## **Important Feasibility Note Regarding The Chiwawa Outlet Restoration Project Conceptual Design Report**

# CHIWAWA OUTLET RESTORATION PROJECT: CONCEPTUAL DESIGN REPORT

November 25, 2020

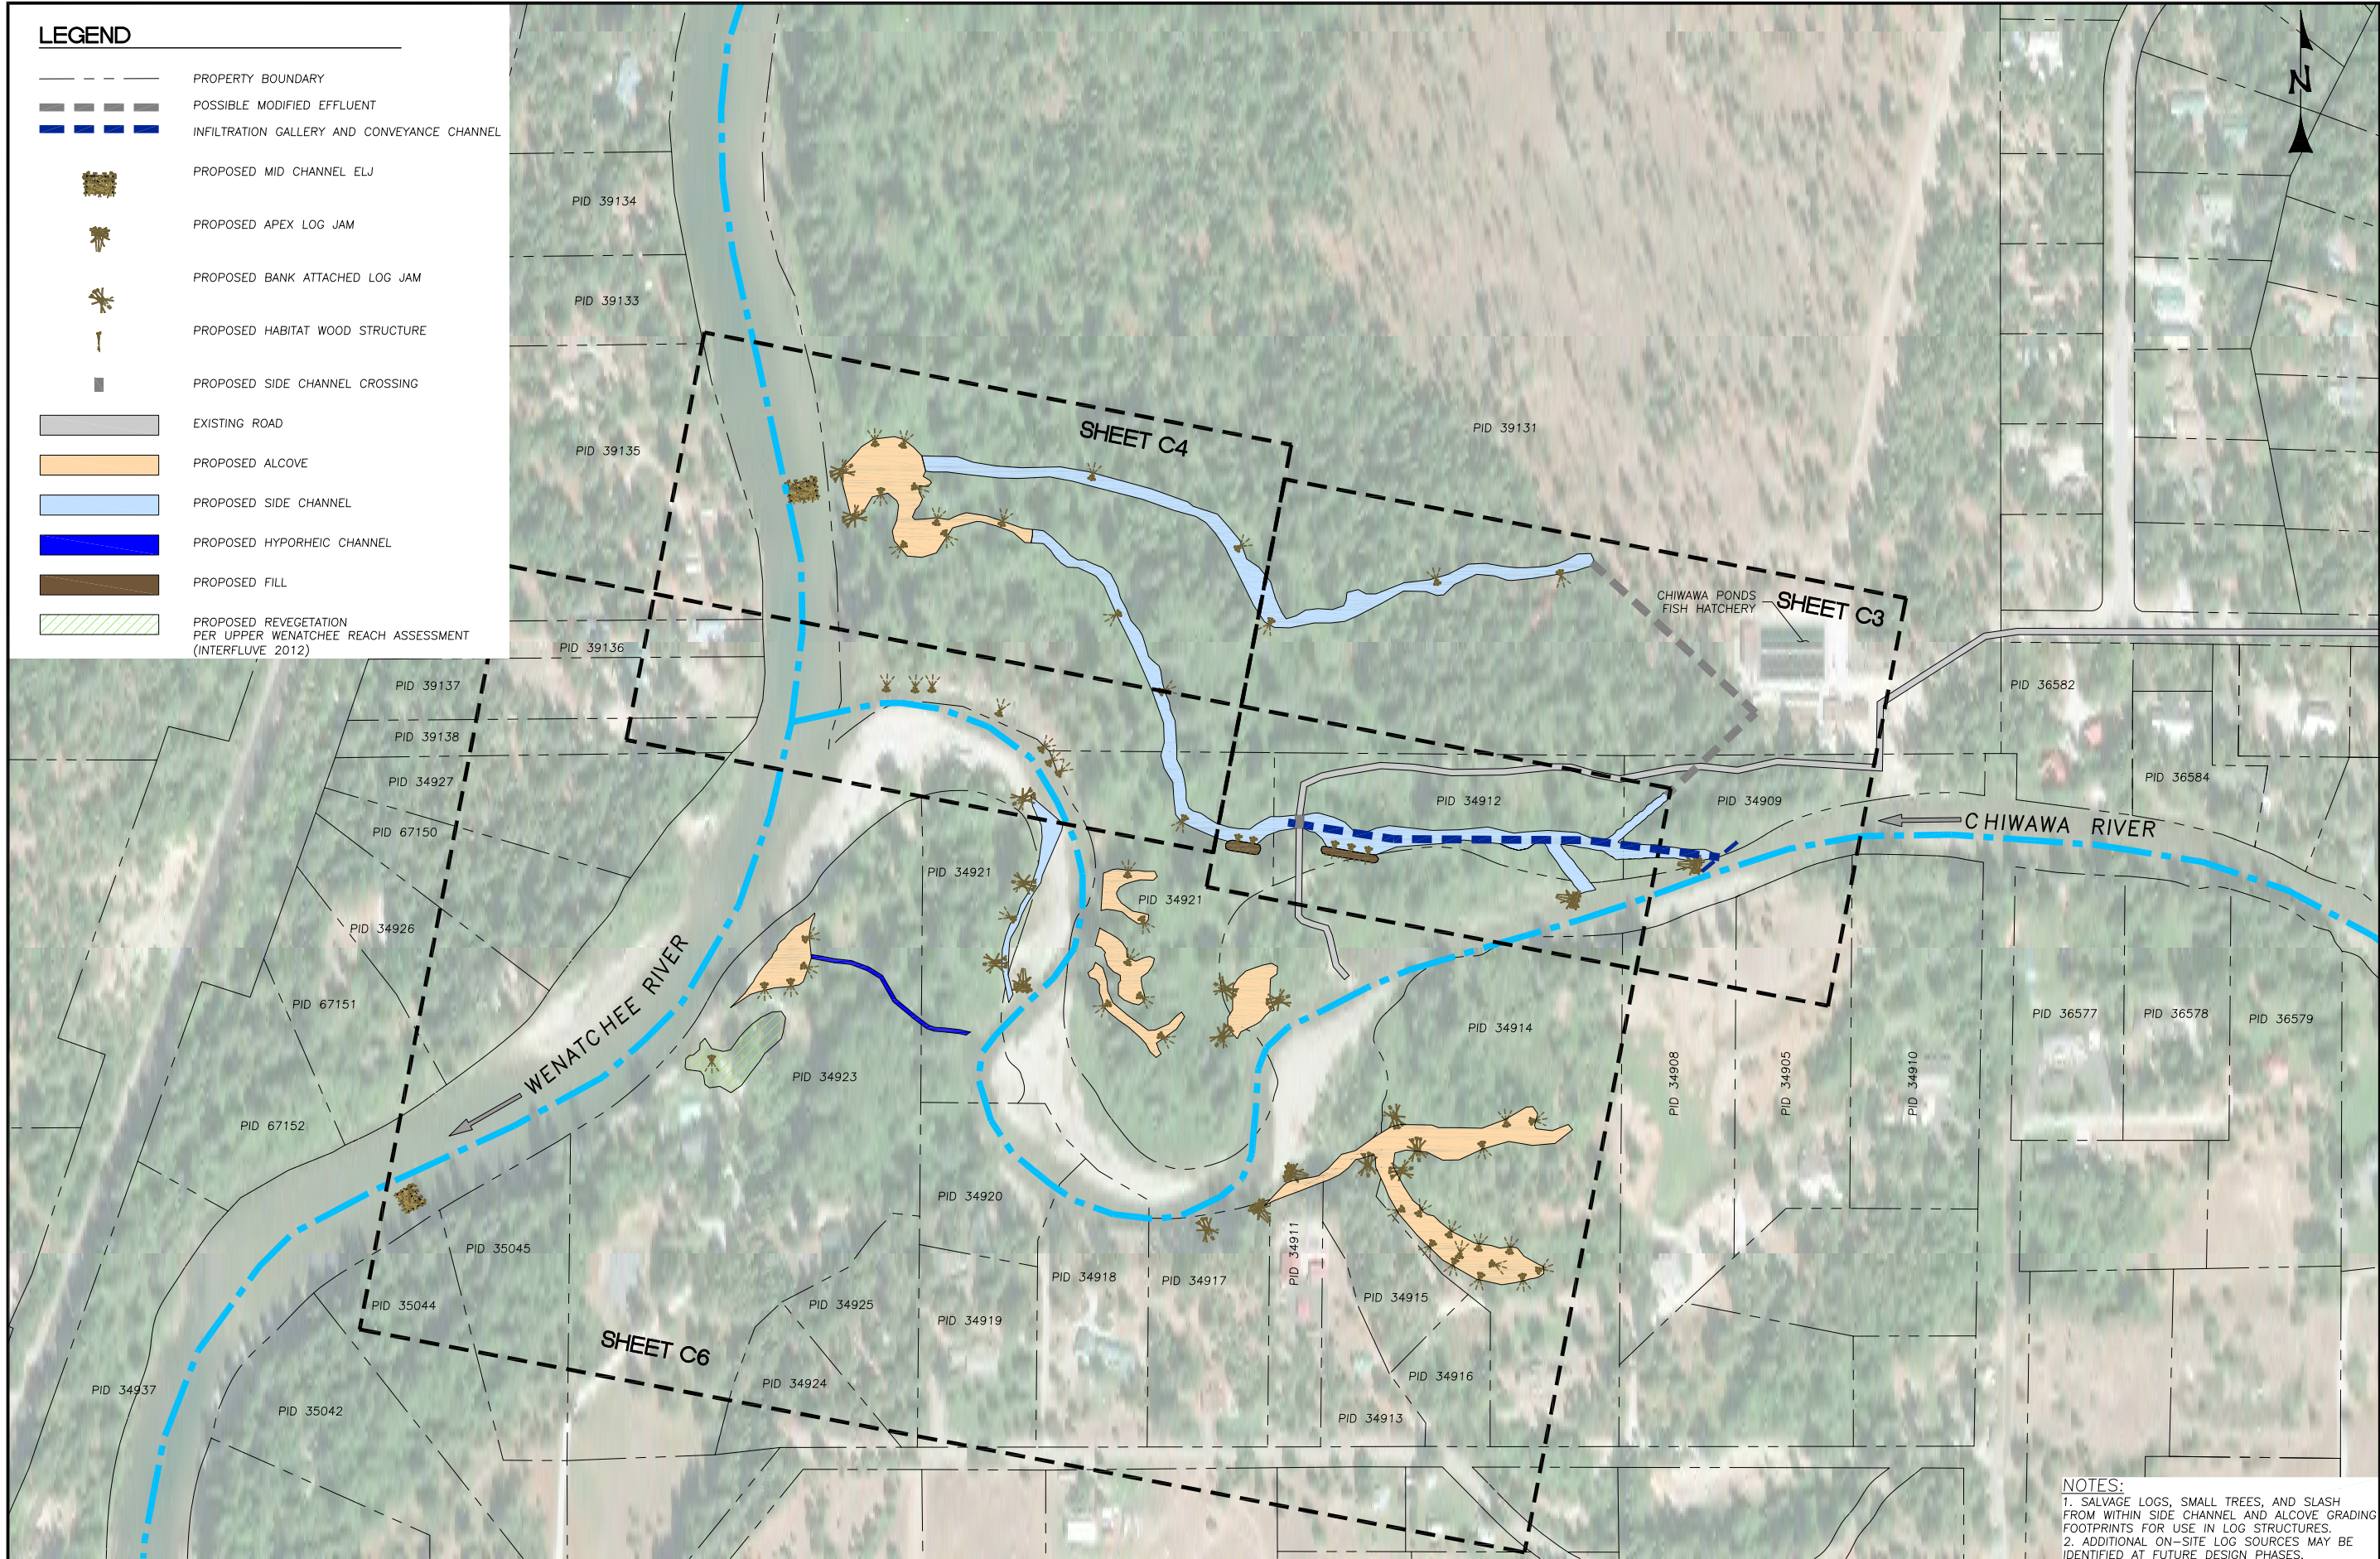
Based on additional investigation and discussion with our partners after publication of the conceptual plans, we do not intend to move forward with the modified effluent options shown on pages C2 & C3 of the Concept Level Design Plans, and as referenced as project element 6 in the Conceptual Design Report. Several reasons for this decision to exclude hatchery effluent discharge as a water source include potential water quality issues, disruption of Chiwawa Hatchery activities, and water right permitting requirements.

Despite the decision to exclude hatchery effluent discharge as a water source, Yakama Nation Fisheries is still very interested in examining opportunities to use existing and/or creating new water diversion infrastructure along the Chiwawa River to achieve similar habitat enhancement outcomes that were conceptualized under project element 6.

The contractor selected to perform design services under this current RFP will assist Yakama Nation Fisheries and the Chelan County PUD in analyzing existing water diversion and transport infrastructure related to the Chiwawa River Hatchery to determine if augmentation of such infrastructure, or creation of new infrastructure, could yield fish habitat benefits as conceived under project element 6.
